FIELD SERVICE BULLETIN

FIELD SERVICE BULLETIN NO. 23
5 DECEMBER 1955

SUBJECT: INSPECTION AND/OR REPAIR OF REAR WING SPAR JUNCTION FITTINGS

EFFECTIVITY: ALL NAVIONS

145-14070 FITTING -
WING REAR SPAR TO
CENTER RIB ATTACH

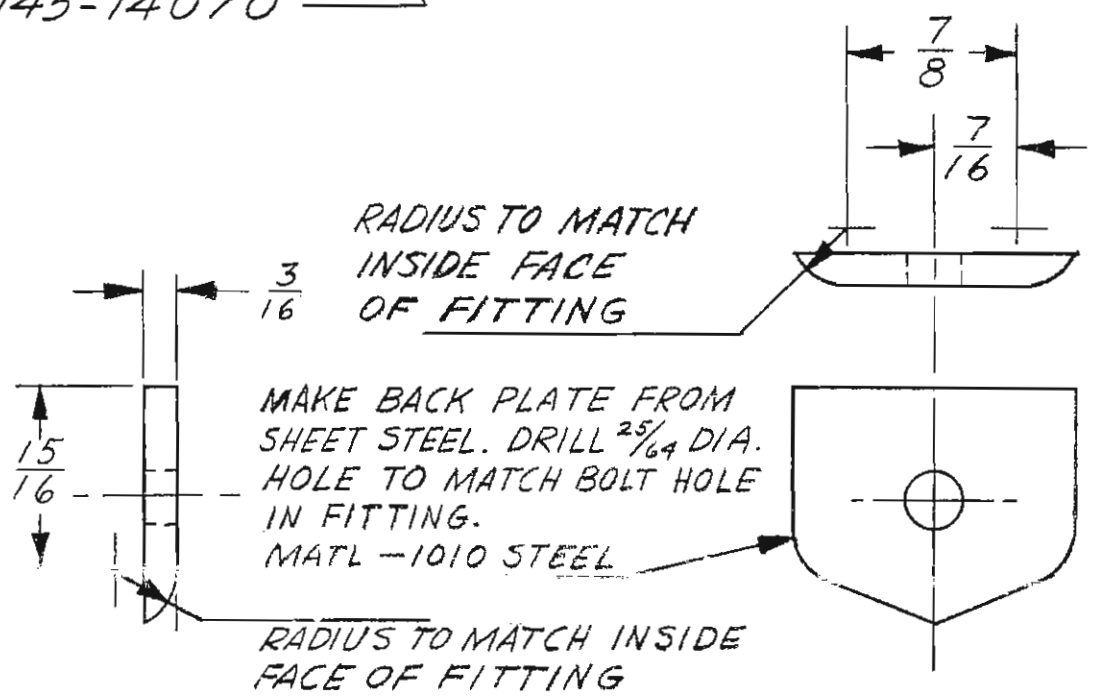
1. Inspection of some Navion aircraft has revealed that cracks may exist in the right, left, or both rear wing spar junction fittings at wing sta. 0.00. Immediate inspection of fittings 145-14070 must be made by removing the bolt connecting the right and left fittings. Access to fittings is through main wheel wells, facing aft.
2. Install back plate, shown on attached sketch, in each fitting.
3. If cracks do exist, stop-drill end of cracks with #60 (.040) drill and install back plates in each fitting.
4. No further inspection will be necessary.
5. It is understood that a C. A. A. airworthiness directive covering this subject will be issued at an early date.

DRILL #60 (.040) DIA.
HOLE AT END OF
CRACK TO PREVENT
FURTHER CRACKING
